UNITED STATES  
DEPARTMENT OF THE INTERIOR  
BUREAU OF LAND MANAGEMENTFORM APPROVED  
OMB NO. 1004-0137  
Expires: January 31, 2018**SUNDRY NOTICES AND REPORTS ON WELLS**  
*Do not use this form for proposals to drill or to re-enter an abandoned well. Use form 3160-3 (APD) for such proposals.*5. Lease Serial No.  
NMNM94651

OXY USA Inc. respectfully requests the following bulk sundry changes to the approved APD's for the following wells:

# OXY USA Inc. – Oxbow CC 17-8 Federal Com 31H-32H-33H – Amended Drill Plan

General well schematic:

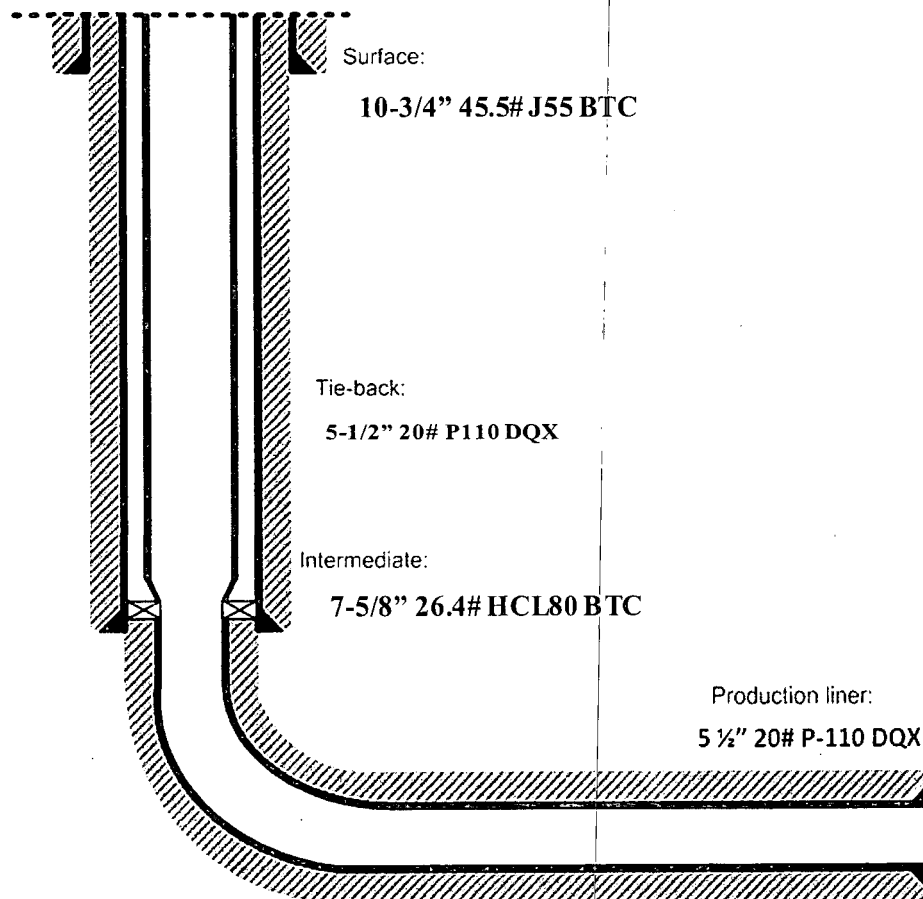
1. Change Production Casing to Liner and update cementing information. See attached for Casing Tie Back Detail
2. Request Bradenhead squeeze for the 2nd stage Intermediate casing with the Bradenhead CBL

1. OXY is requesting permission to have minimum fill of cement behind the 5-1/2" production liner to be 100' into previous casing string. The reason for this is so that we can come back and develop shallower benches from the same 7-5/8" mainbore in the future.
2. Our plan is to use a whipstock for our exit through the mainbore. Based on our lateral target, we are planning a whipstock cased/hole exit so that kick-off point will allow for roughly 10deg/100' doglegs needed for the curve.
3. Cement will be brought to the top of this liner hanger.
4. See attached for additional casing tie-back information.

- Drill 14-3/4" hole x 10-3/4" casing for surface section. Cement to surface.
- Drill 9-7/8" hole x 7-5/8" casing for intermediate section. Cement to surface.
- Drill 6-3/4" hole x 5-1/2" liner for production section. Cement to top of liner, 100' inside 7-5/8" shoe.
- Release drilling rig from location.
- Move in workover rig and run a 5-1/2" 20# P110 DQX tie-back frack string and seal assembly (see connection specs below). Tie into liner hanger Polished Bore Receptacle (PBR) with seal assembly.
- Pump hydraulic fracture job.
- Flowback and produce well.

When a decision is made to develop a secondary bench from this wellbore, a workover rig will be moved to location. The workover rig will then retrieve the tie-back frack string and seal assembly before temporarily abandoning the initial lateral.

3. The minimum required fill of cement behind the 5-1/2 inch production liner is:
  - Cement should tie-back **100 feet** into the previous casing. Operator shall provide method of verification. **Excess calculates to 5% - additional cement might be required.**
